Lewis Central Community School District 4121 Harry Langdon Blvd. Council Bluffs, Iowa 51503

Addendum #1 2026-#01

High School Partial Roof Replacement December 23, 2025

Addendum 1 clarifies and corrects roof overflow drain locations and parapet metal locations.

REROOF PLAN

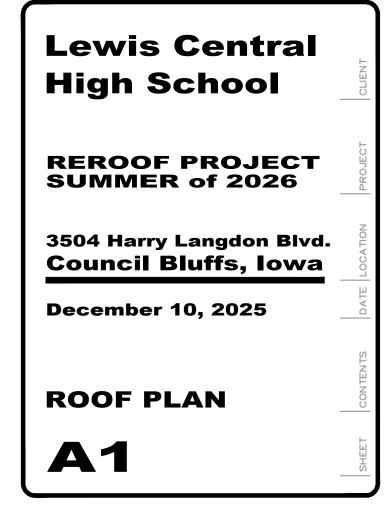
Exist Scupper SLOPE SLOPE No overflow ADDENDUM 1 12.23.25 - Roof Clarifications on Overflow quantity and parapet metal locations Exist Scupper SLOPE ROOFTOP UNIT No overflow SLOPE Exist Scupper No overflow TAPERED INSULATION SHADED PARAPET IINDICATES WHERE DETAIL 3/A1 APPLIES APPROXIMATE REROOF AREA = 47,200 SF DRAWING IS TO APPROXIMATE SCALE OF 1"=20'-0" CONTRACTOR RESPONSIBLE TO FIELD MEASURE ALL AREAS SLOPE TAPERED INSULATION IN THESE AREAS — (ALL OTHER AREAS AREAS ARE SLOPED STRUCTURE) SLOPE SHADED PARAPET IINDICATES WHERE DETAIL 3/A1 APPLIES = No Parapet Metal. EPDM Wrapped Curb SHADED PARAPET IINDICATES — WHERE DETAIL 3/A1 APPLIES SLOPE L SLOPE SLOPE SLOPE Exist Scupper SLOPE - ROOFTOP UNIT No overflow SLOPE SLOPE SLOPE SLOPE S L O P E SLOPE SLOPE SLOPE SLOPE SLOPE ROOFTOP UNIT \sim ROOFTOP UNIT Exist Scupper CONSTRUCTION NOTES: ROOFTOP PENTRATIONS 1. CONTRACTOR TO PROTECT EXISTING STRUCTURE, FINISHES, PAVEMENT AND GRASS. REPLACE ANY DAMAGED ITEMS. No overflow VERIFY NUMBER, LOCATION AND SIZES IN FIELD (NOT ALL SHOWN) 2. COORDINATE SUMMER ACCESS WITH DRIVE LANE AND PARKING LOT REPLACEMENT ON EAST SIDE OF SCHOOL. ROOF SCUTTLE S L O P E S L O P E SLOPE SLOPE Exist Scupper PAVERS TYPICAL No overflow ROOFTOP UNIT
